**Preliminary Acceptance Punchlist**  
**El Paso County – Department of Public Works - Stormwater Section**

Project Name:	Rolling Hills Ranch Filing 3
EDARP Filing Number(s):	SF2116
ESQCP Number:	ESQ2329
Attendees:	DPW SW: Dylan Finley DPW Development Services: Brad Walters, David Parkerson, Spencer Pirzadeh, Gilbert LaForce Developer: Lawrence Grahem
Date of Walk-Thru:	08/02/2023
Walk-Thru Number:	1

Photo 2: Inlet at Coastal Hills and Crooked Hill Dr.

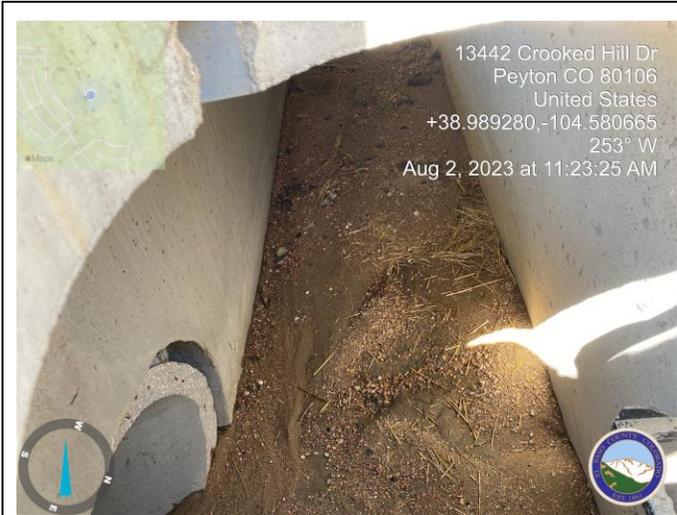
- Inlets need to be cleaned of sediment:
  - Inlet #21: Rolling Ranch Dr. and Crooked Hill Dr. (Photo 1)
  - Inlet #20: Coastal Hills and Crooked Hill Dr. (Photo 2)
  - Inlet #19: Crooked Bluff Dr. and Crooked Hill (Photo 3)
  - Inlet #22: Along Rolling Ranch Dr. (Photo 4)
